- 
- BIRCHWOOD LOFT C -2022
- SITE: WHITETAIL RIDGE PHASE 4
- LOT NUMBER:
- CIVIC ADDRESS:  
168 FRANK FISHER CRESCENT
- 118
- |           |                        |          |    |

May 2, 2023 (Revised)

**Second Floor Plan – Pages # 4:**

BASEMENT PLAN WITH LOFT  
ELEVATION C  
13 SQ FT

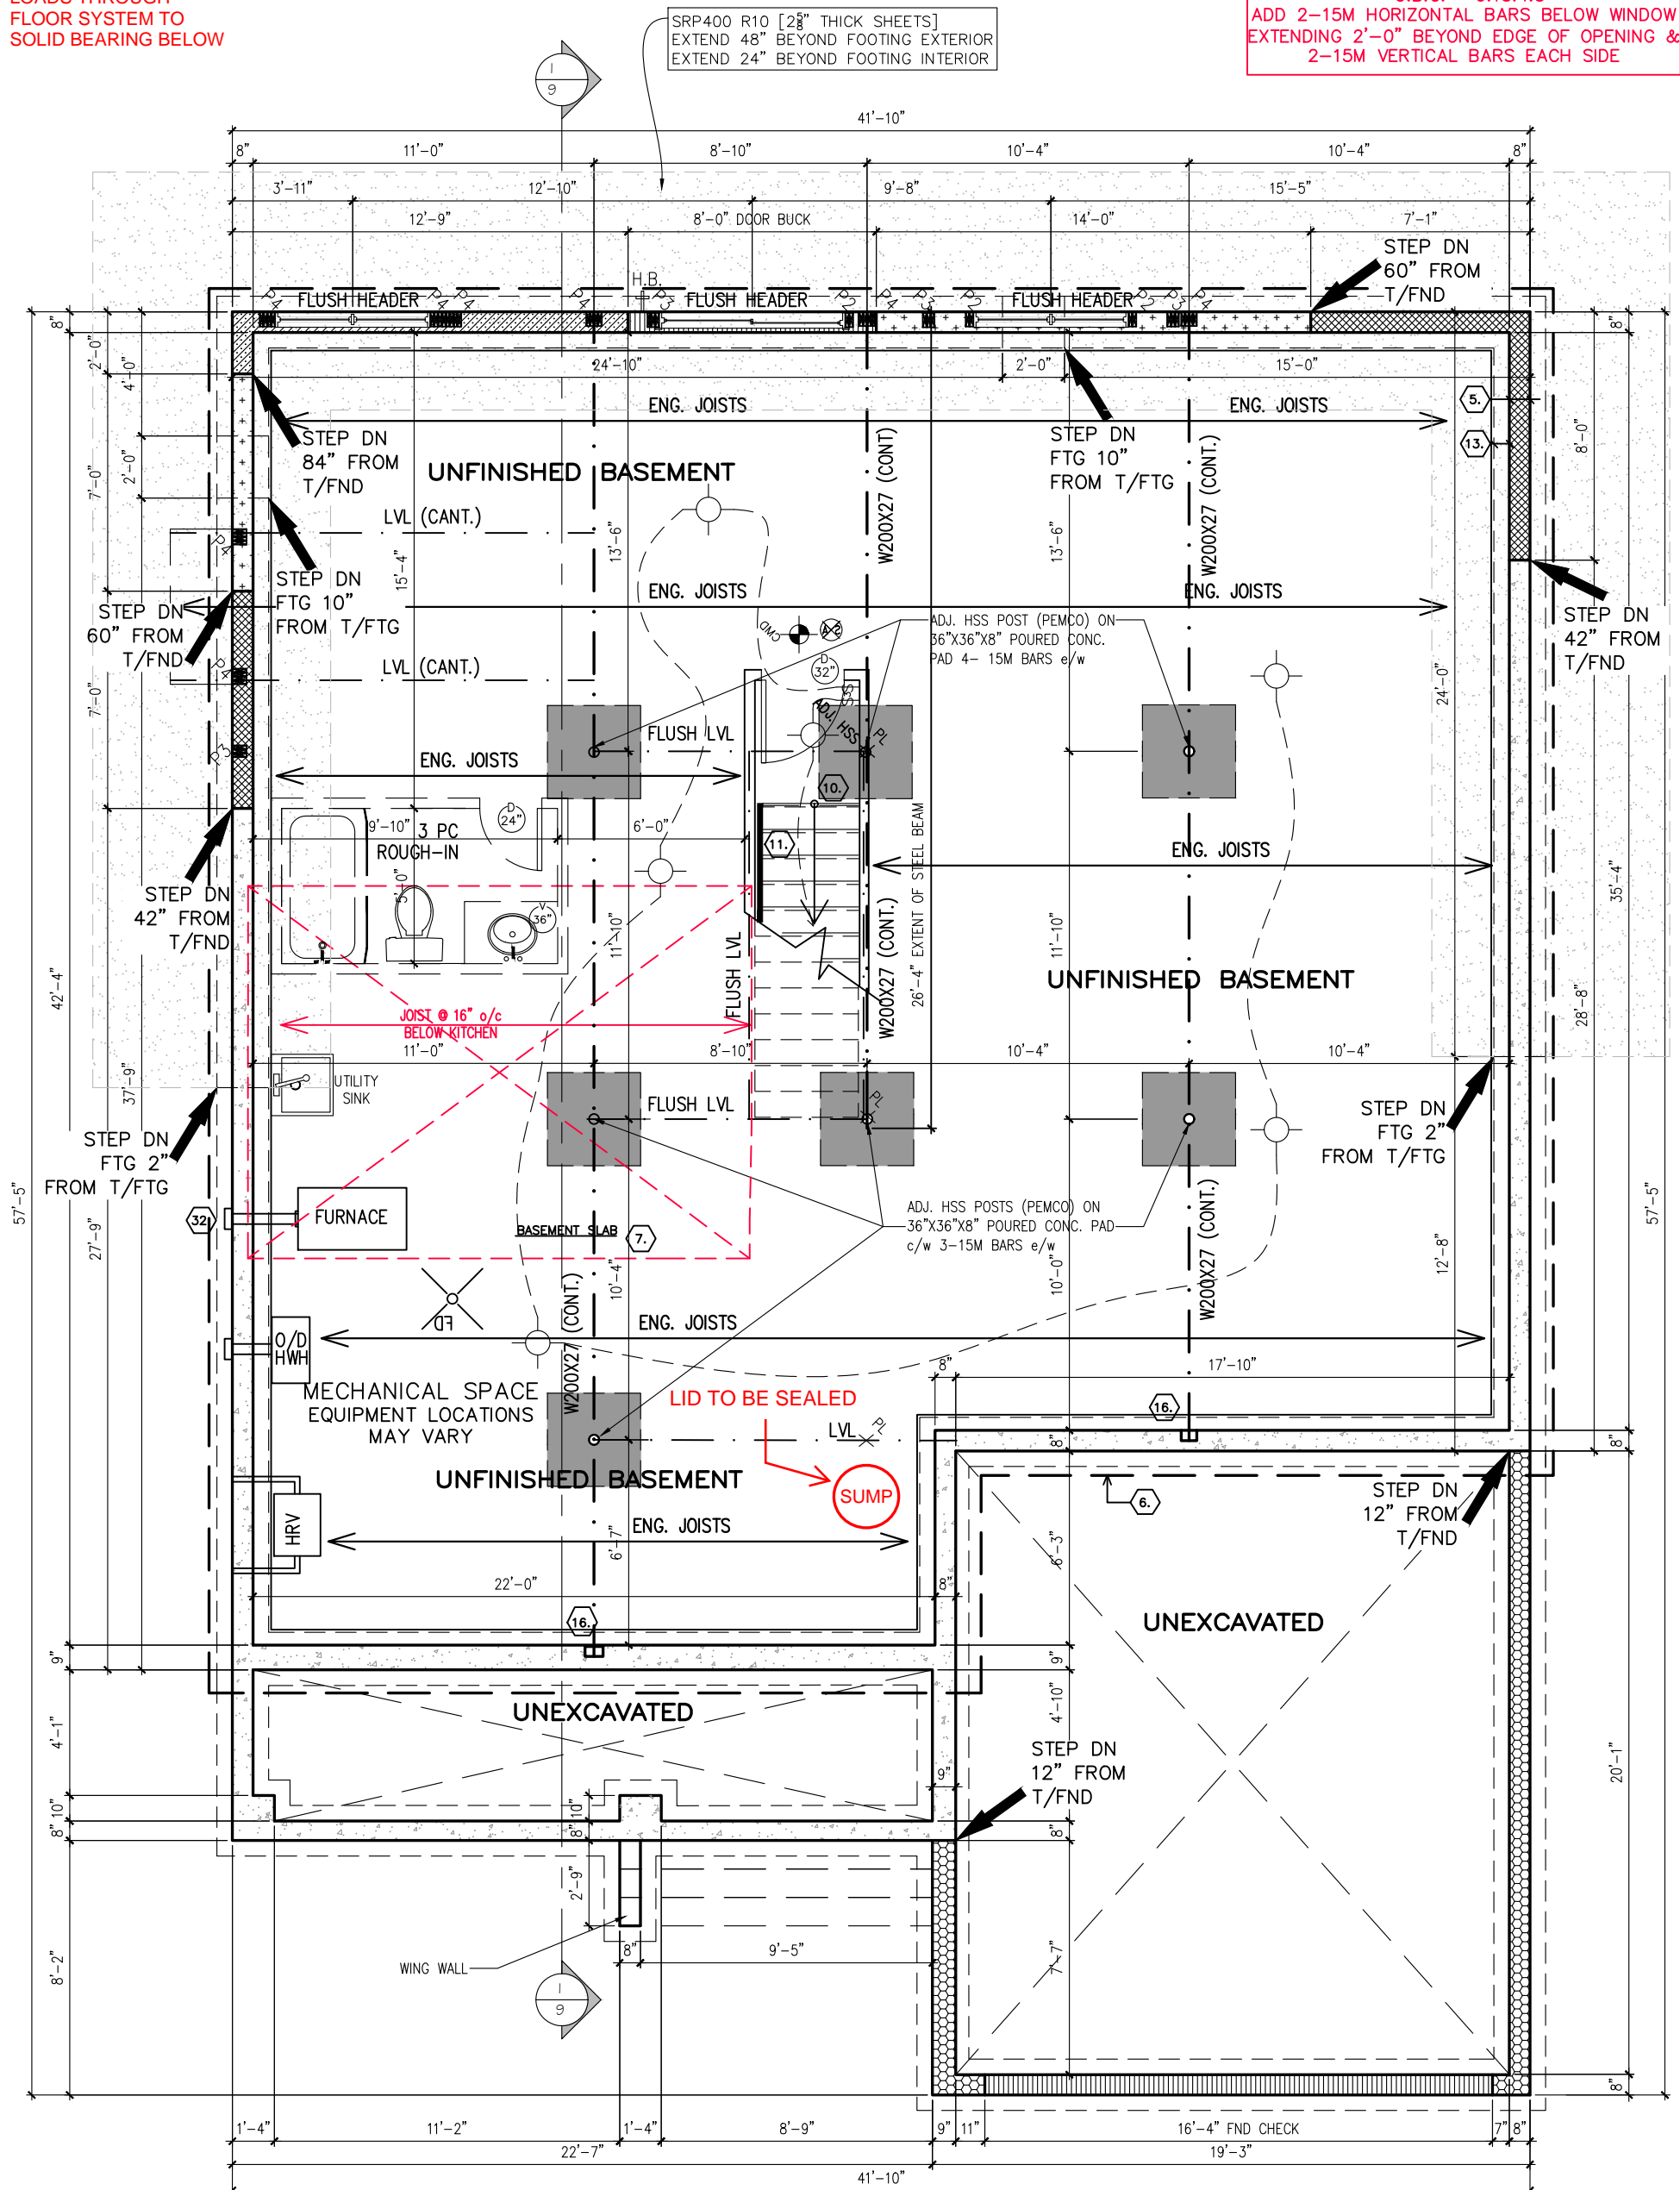
Basement Plan – Pages # 2:

GROUND FLOOR  
ELEVATION C  
1689 SQ FT

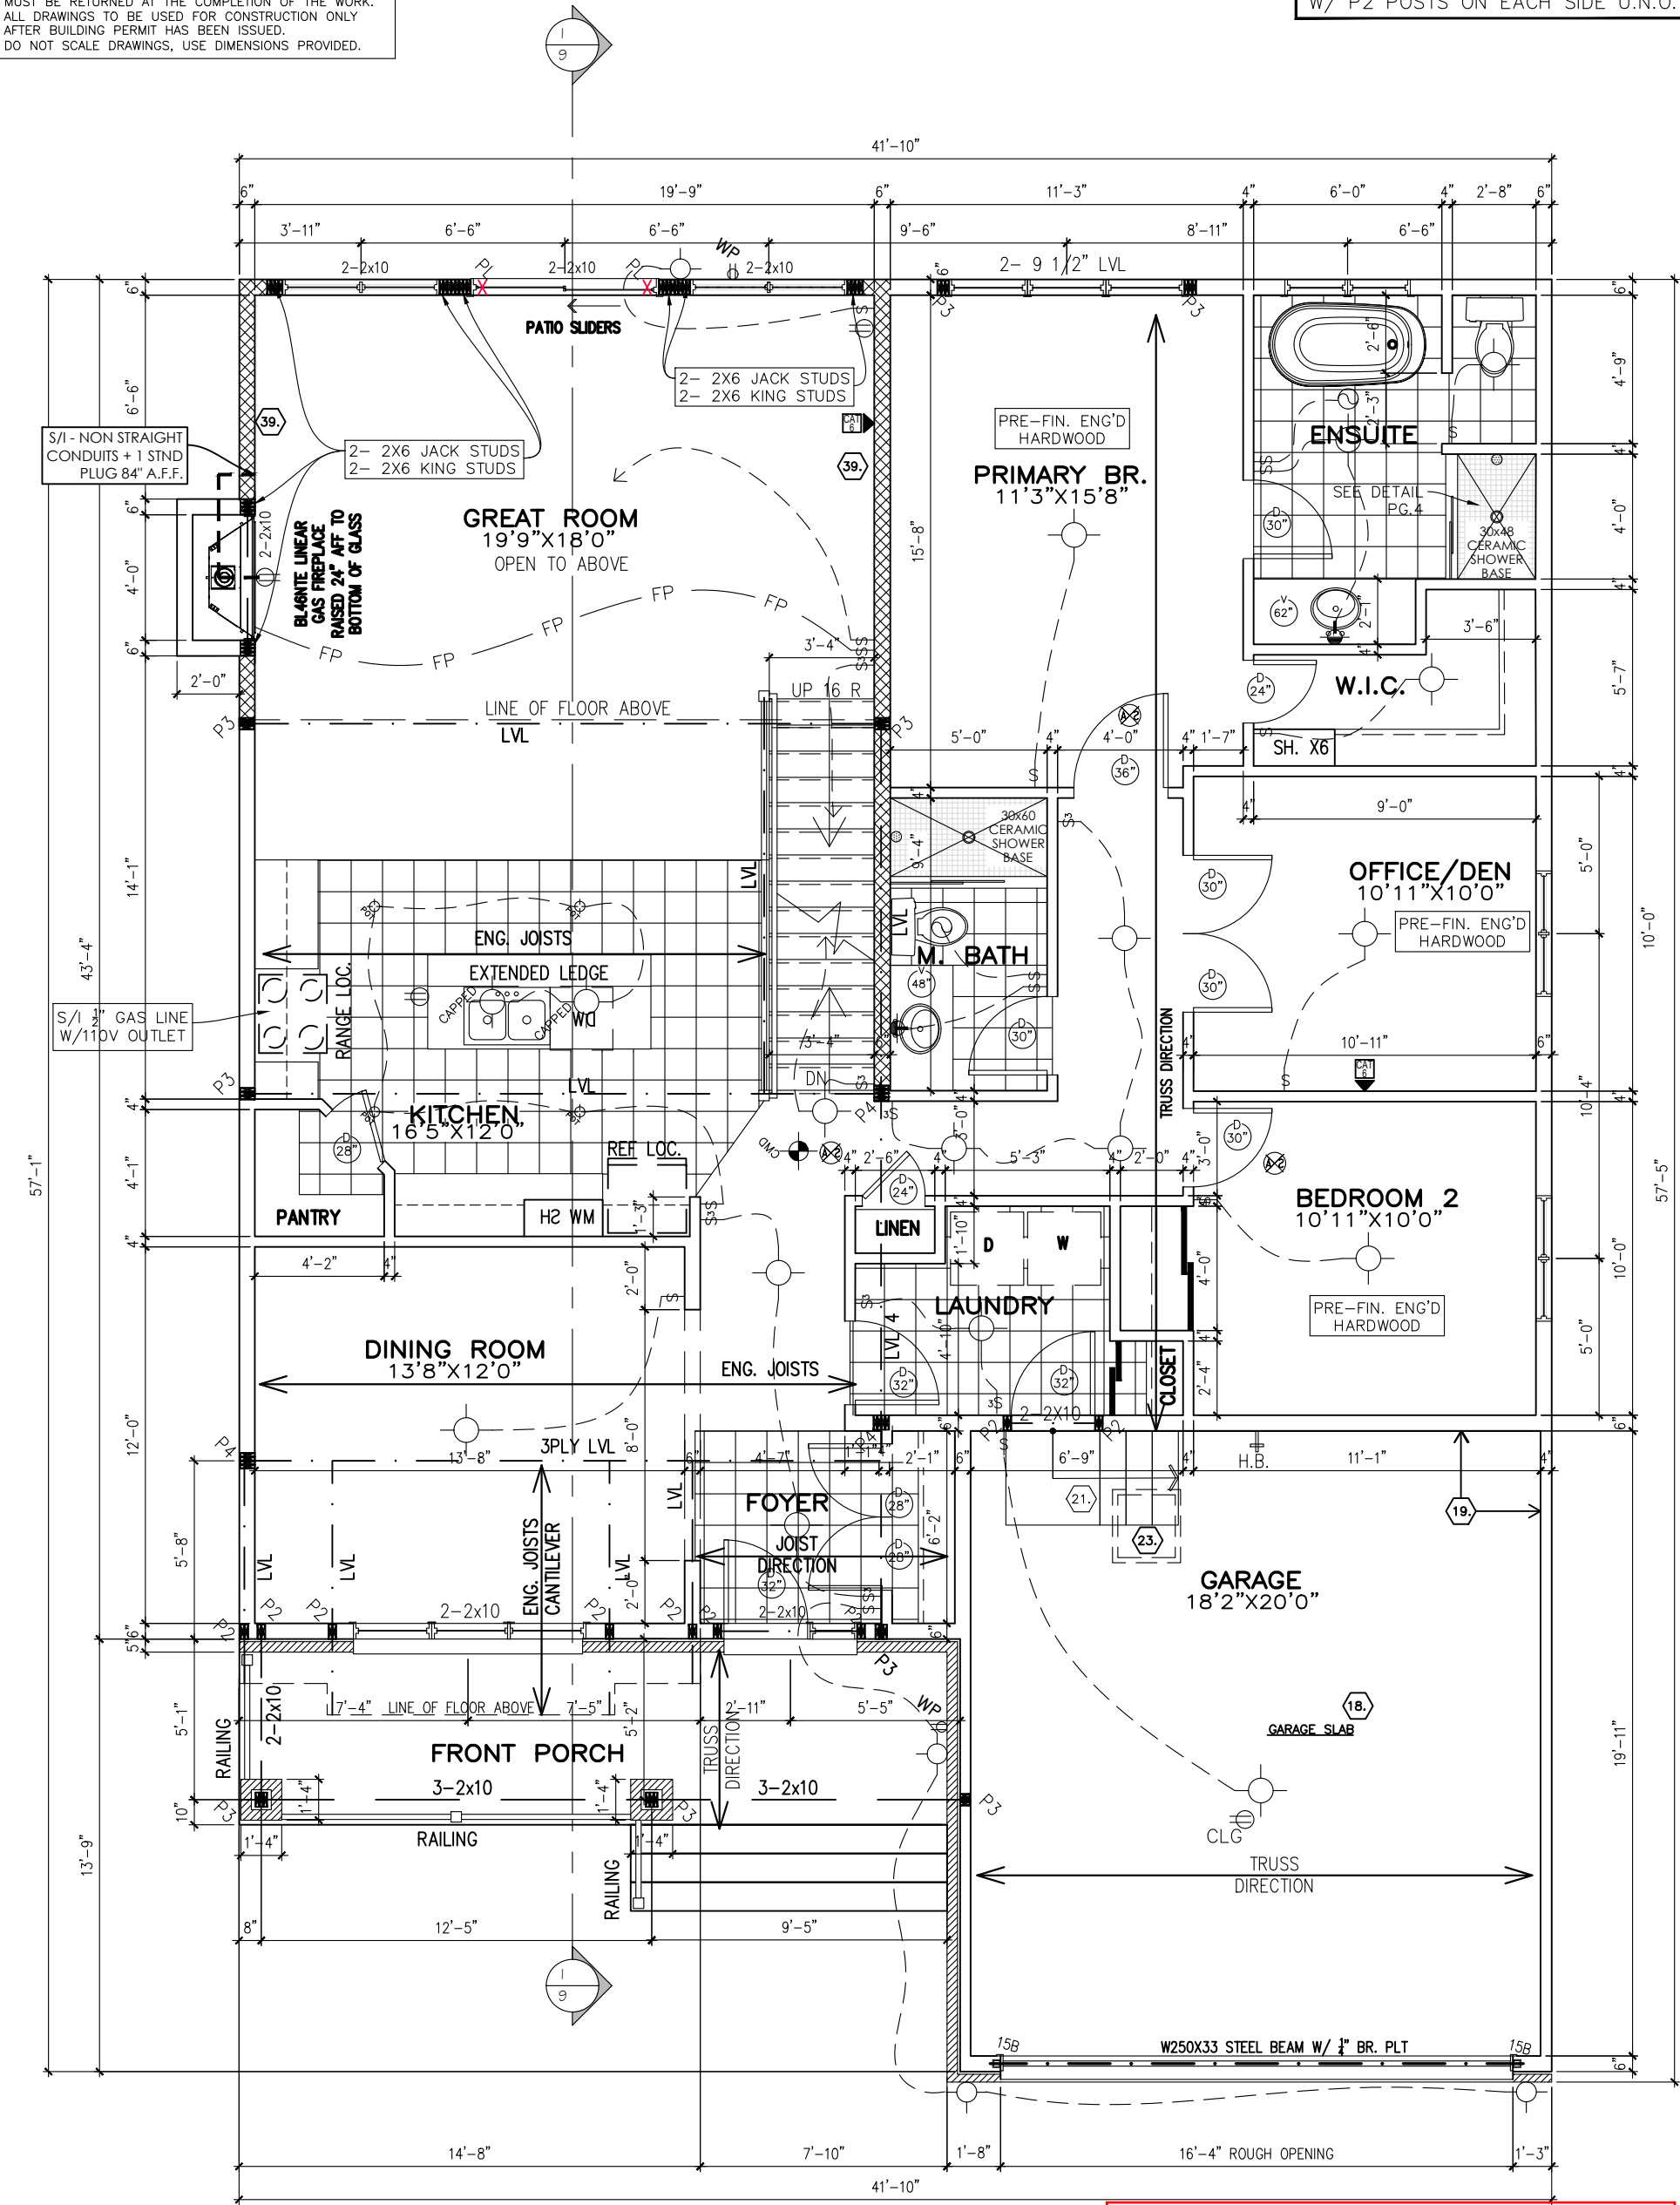
**Ground Floor Plan – Pages # 3:**

SECOND FLOOR PLAN  
ELEVATION C  
661 SQ FT

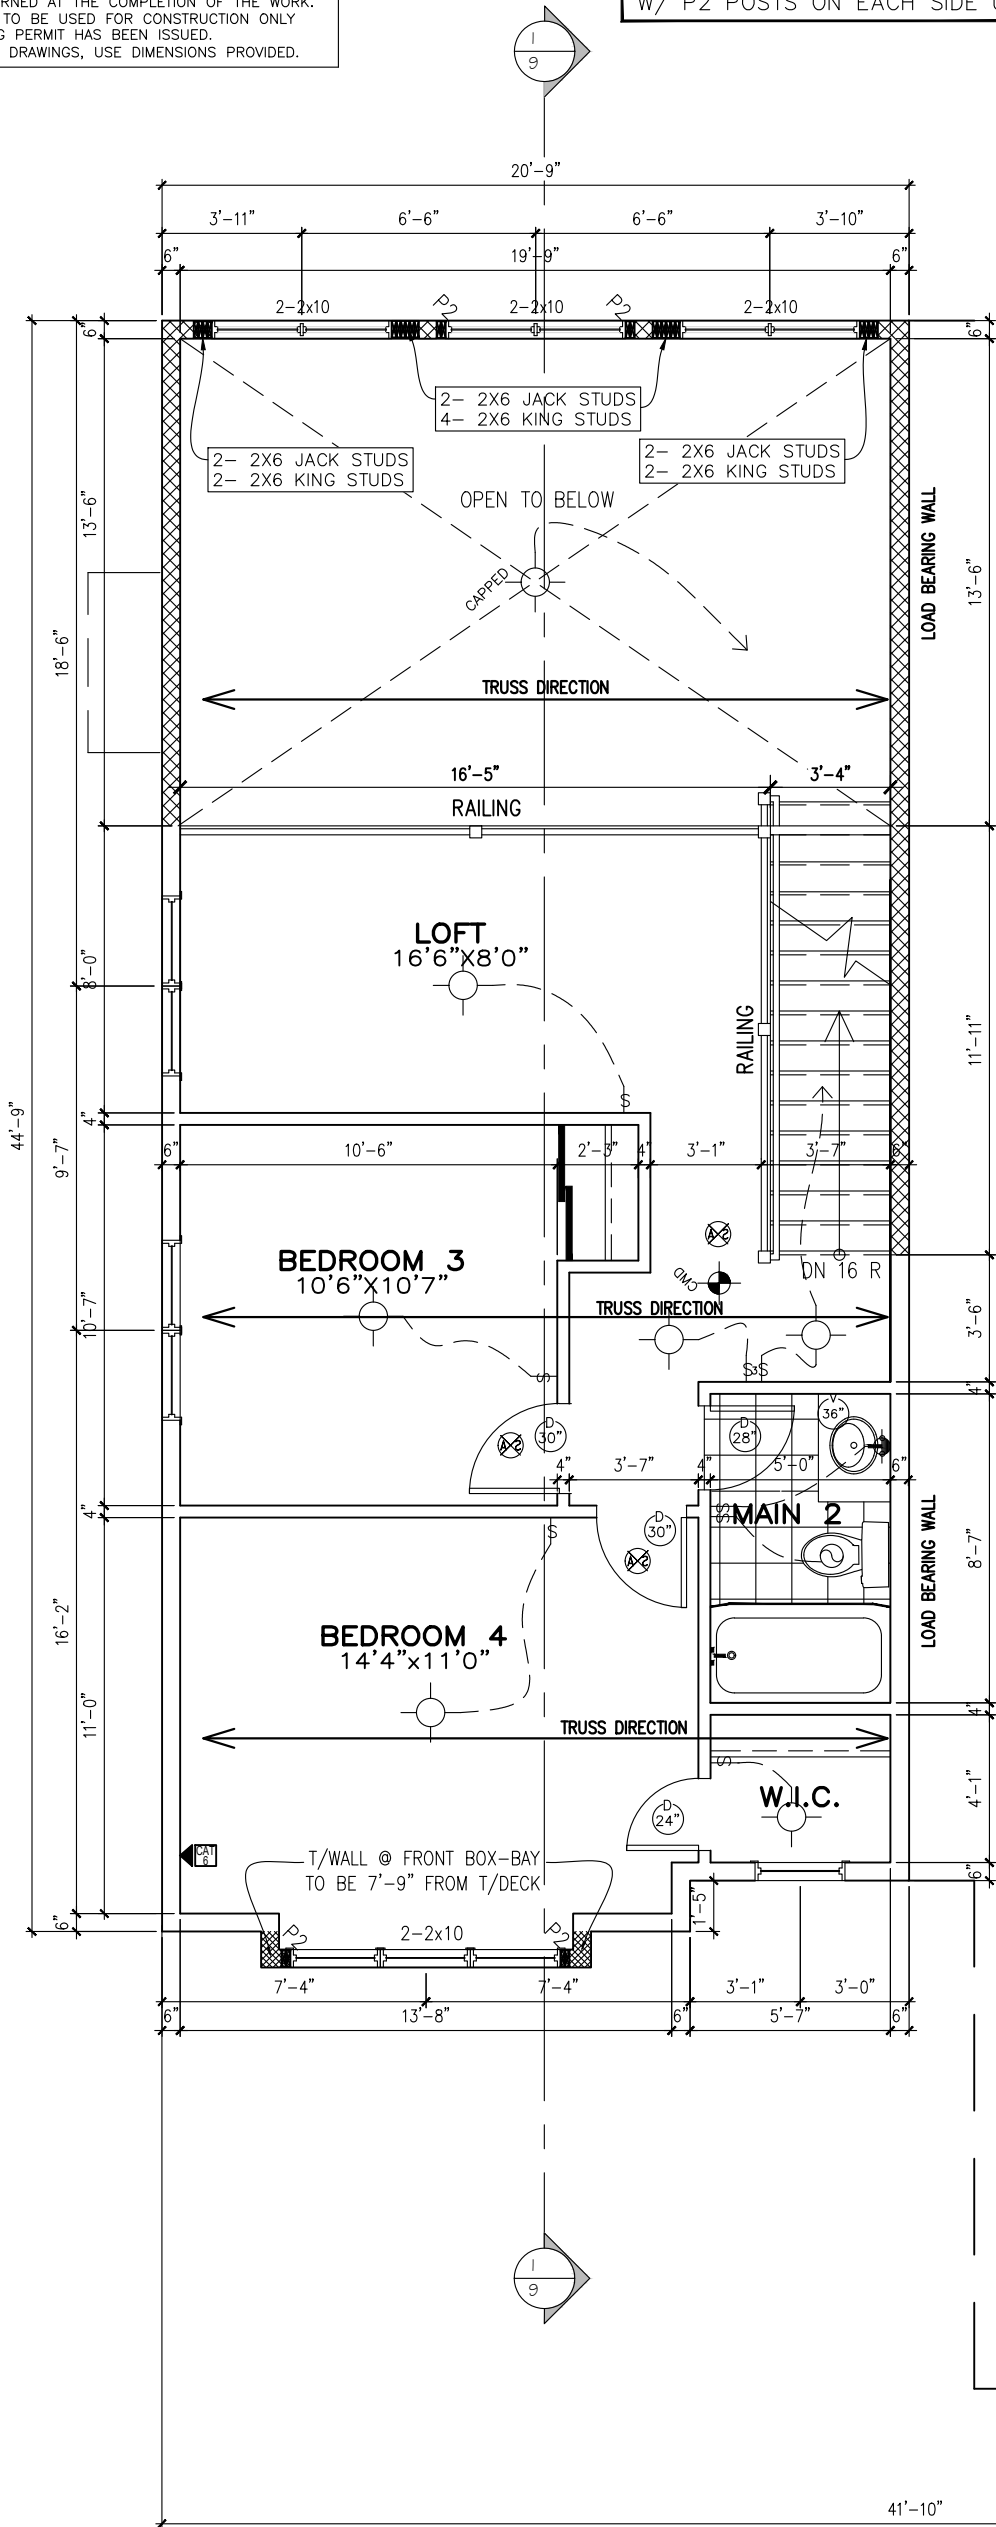
1. It is the opinion of Kollaard Associates that the proposed beams, lintels and built-up wood posts shown on Phoenix Homes Pages # 4 are adequate.
2. The proposed tall wall noted on Phoenix Homes Sheet # 1 is adequate.
3. Truss design is by others.
